## **Charge Control C Errata**

chargebyte GmbH

Oct 26, 2023

Figure 1 Placement of R281

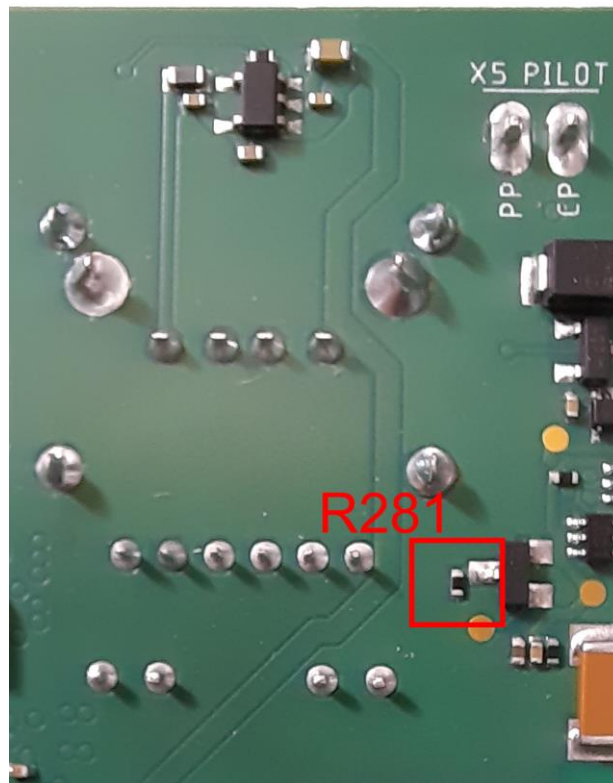
It was found that a logic gate might suffer from an open input due to a missing resistor on its input. Open inputs on logic gates are forbidden by common design rules, since the behaviour of logic gates is general unpredictable/not defined for such cases.

This missing resistor (R281) is part of the Control Pilot control circuit. It is placed on the bottom side of the PCB, see following photo (where R281 is already populated).

Therefore, the Control Pilot interface, particularly the generation of the pulse-width modulation (PWM), might misbehave or does not function at all.

No workaround exists, only fixing is possible by populating the missing resistor.

Affected products (see chart above) which are shipped after July 1st, 2021 are reworked to include the missing resistor.

Additionally, new product versions (V0R5e and following) are created and released to customers which include the missing part by design.
